SEWAGE DISPOSAL SYSTEM

MARYLAND STATE DEPARTMENT OF HEALTH

SUBDIVISION 1/Roscommon Estates ROAD 3207 Rosway Court LOT 17

GRADING STUDY	
LOT 17 "ROSCOMMON ESTATES"	
3 RD. ELECTION DISTRICT HOWARD COUNTY, MD.	
SCALE 1"=100'	MAY 24, 1989

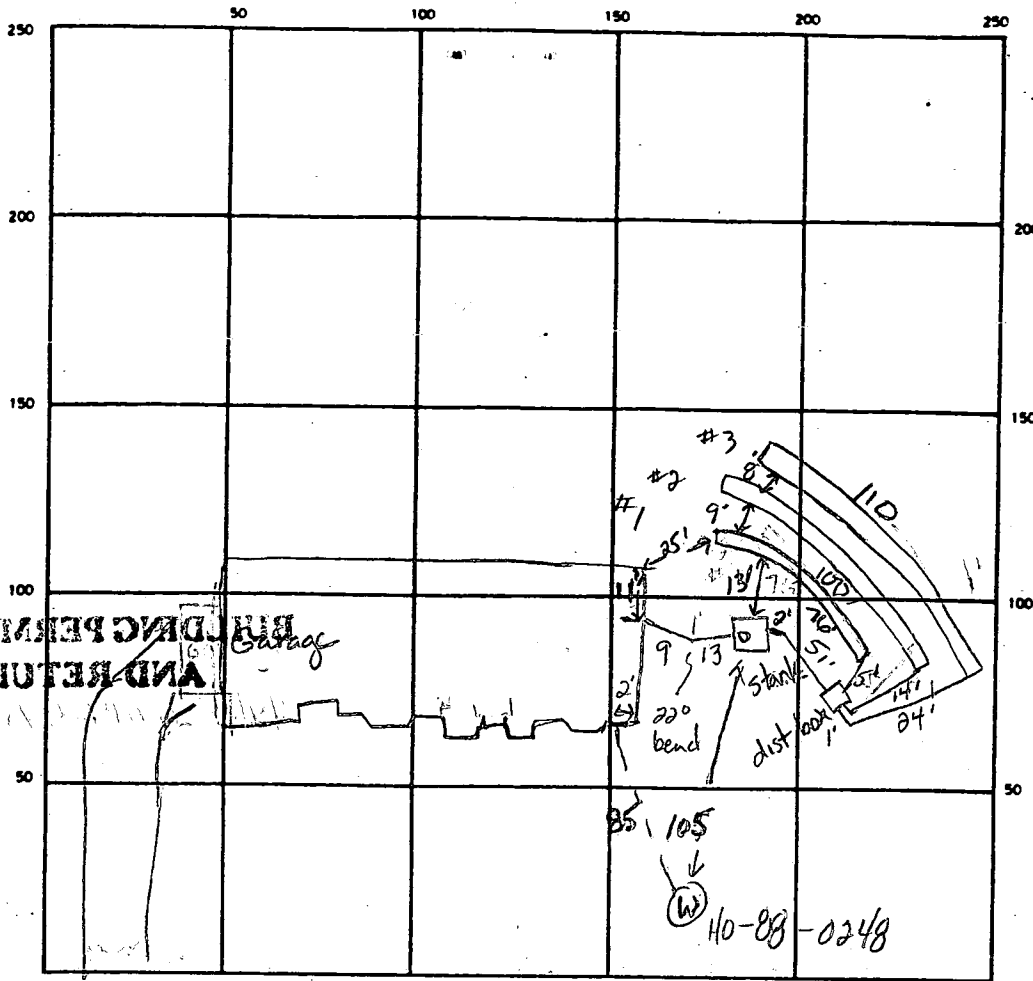
Ken Clarke Plumbing
 10-31-89
 WPI
 2 1/2 in to P.A.
 Line in trench
 covered
 House connect ok.
 Ground not connected.
 EN

SEPTIC TANK LEVEL 1500 gal CLEANOUTS Lon s tank

DISTRIBUTION BOX LEVEL ok w/ baffle

REMARKS 10-31-89 OK to continue with trenches JEN. 10-31-89 OK to stone trench #1 and cover leaving both ends open, OK to cover from house to dist. box. JEN 11-2-89 OK to cover all work except end of trench #3 to inlet depth. JEN 11-2-89 OK to cover all work. JEN

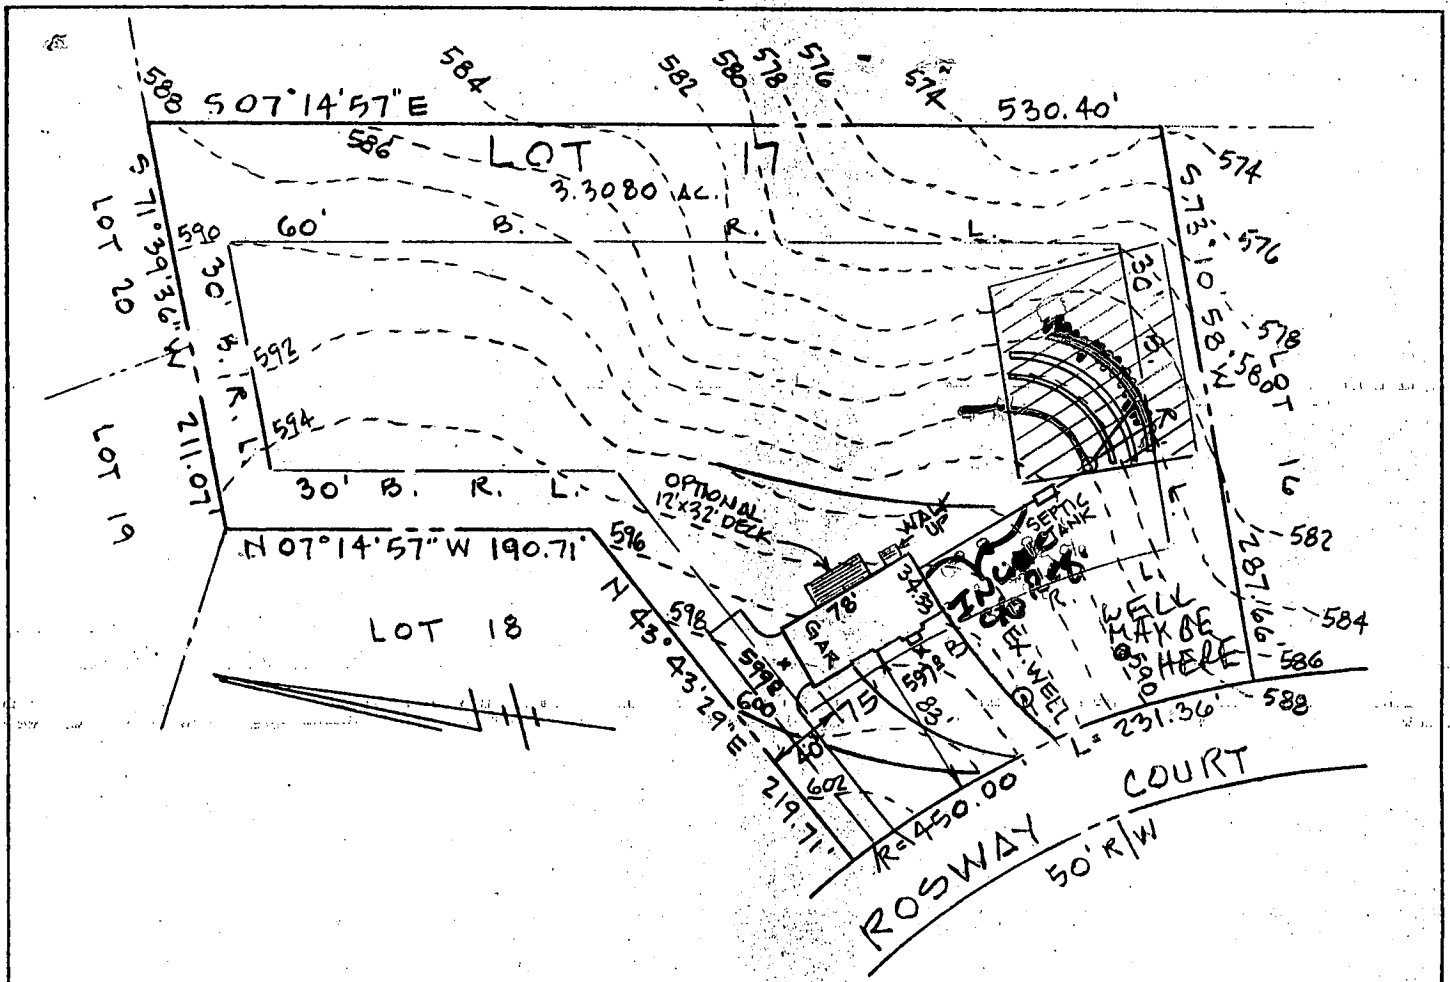
REMARKS NOT AS PER TEST PLOT - SWALES CONSTRUCT ORIGINAL PROPOSED AREA

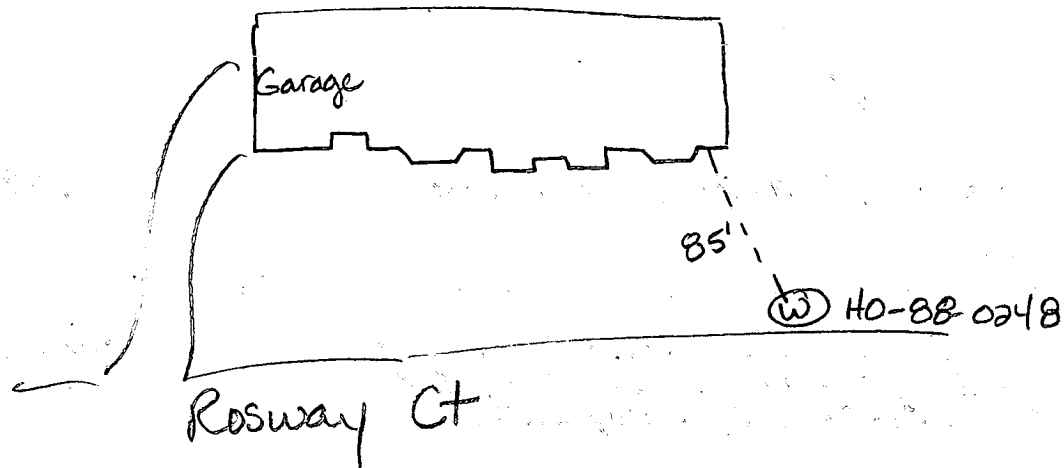
Pitless adaptor at 46 inches below grade. Line in trench covered. Ground not connected yet. No pump tanks. House connection ok. JENadeau
